## MODIFICATION

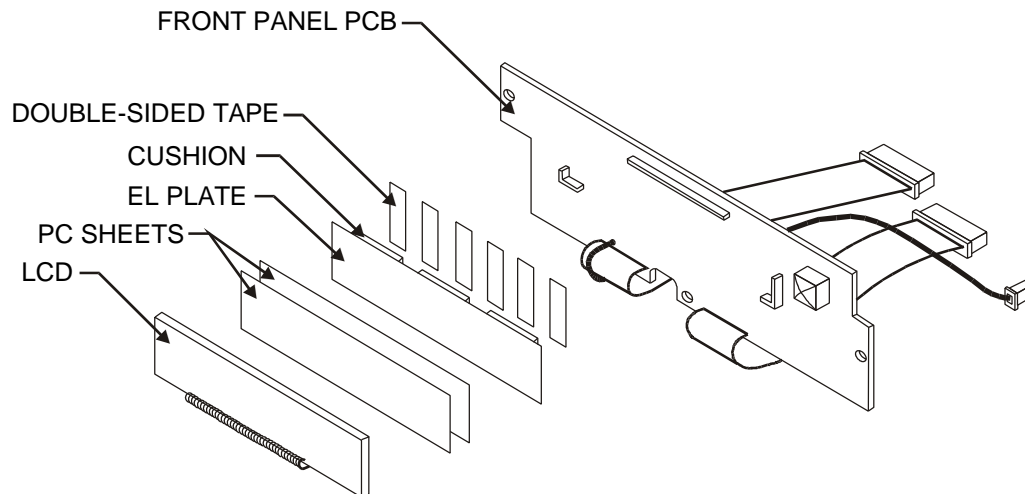
You may receive a complaint of the unit producing a very high whistle noise

The step up transformer for the display circuit is humming

1. Insert a transformer with more varnish impregnation
2. Apply glue to fix the step-up transformer to the main pcb
3. Add double sided tape between the cushion at the back of the EL display and the front panel pcb.  
Please refer to the drawing below
